Residential Technical Services: YS Letter

Letter: YSR-001-26

Subject: **Condensing Furnace Condensate Collection Pan Screws**

Product/s: Condensing Furnace Models - Z9E (T, S), Y9(1,2), RG19, YP9C, TP9C, LP9C, TM9(E, Y, V)

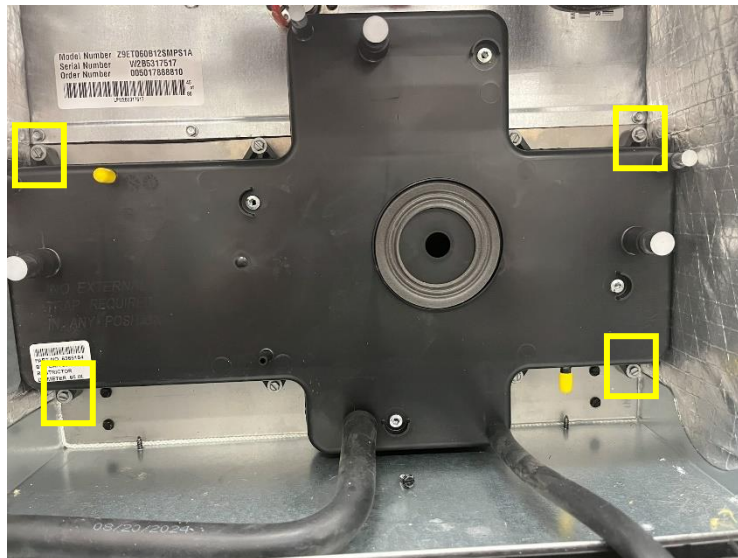
(Note) Below are common areas of concern for customer awareness

For units installed in the field, repairs are recommended **only if the condition is present**. When required, approved replacement fasteners may be installed to restore a secure seal. This repair is straightforward and does not involve replacing major components. If your furnace is within the affected serial number range and you believe it may be experiencing this issue, please proceed with ordering the screws listed below and performing the repair. Warranty support is available in accordance with standard terms.
